IEEE 802.3cg

Interworking between PLCA enabled nodes with non-PLCA enabled nodes

August 15th, 2018

Figure 148-5—PLCA Control state diagram (2 of 2)

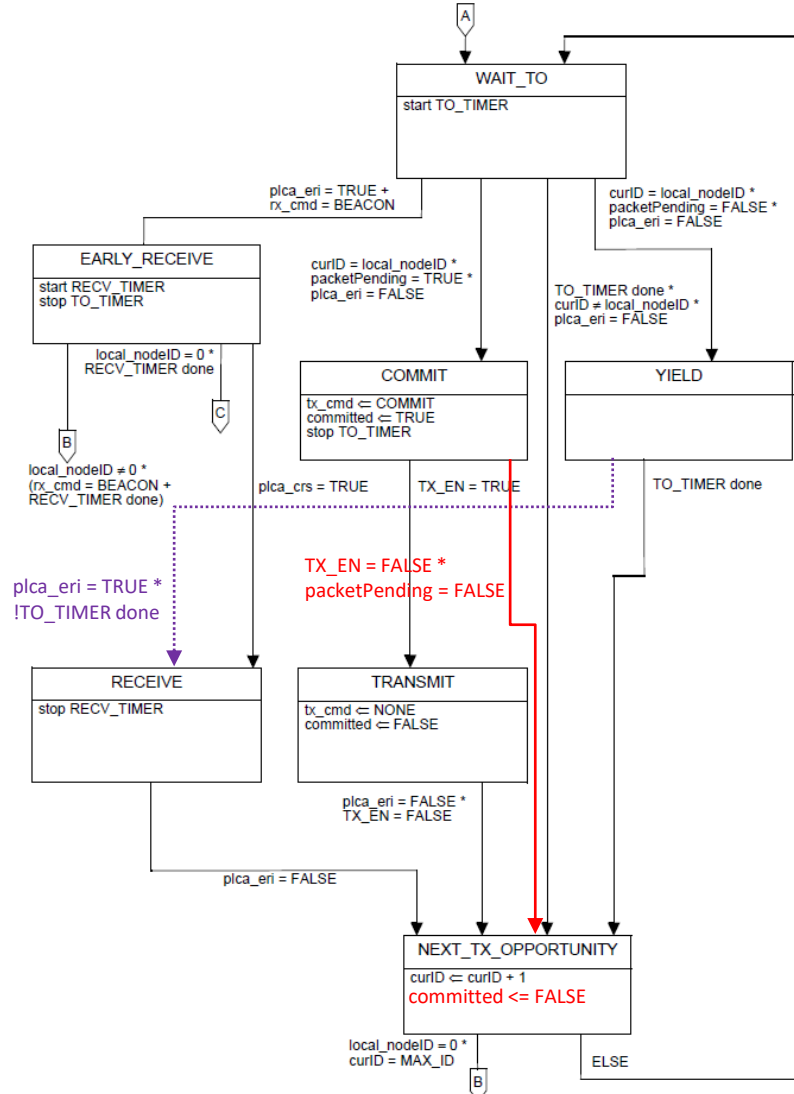
Add transition from YIELD to RECEIVE state with condition
“ $plca_eri = TRUE * !TO_TIMER$ done”

Add transition from COMMIT to NEXT_TX_OPPORTUNITY state with condition “ $TX_EN = FALSE * packetPending = FALSE$ ”

Add “ $committed \leq FALSE$ ” in NEXT_TX_OPPORTUNITY state box

Figure 148-7—PLCA DATA state diagram (2 of 2)

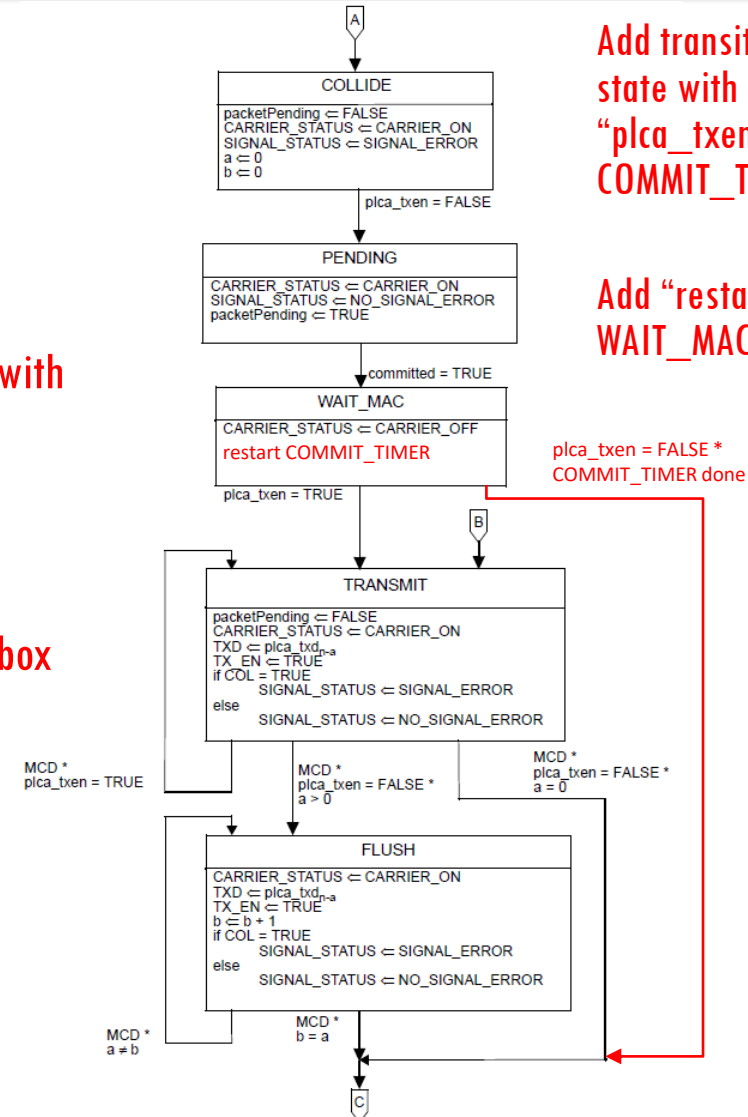
Add transition from WAIT_MAC to C state with condition
“ $plca_txen = FALSE * COMMIT_TIMER$ done”

Add “restart COMMIT_TIMER” in WAIT_MAC state box

$plca_txen = FALSE * COMMIT_TIMER$ done
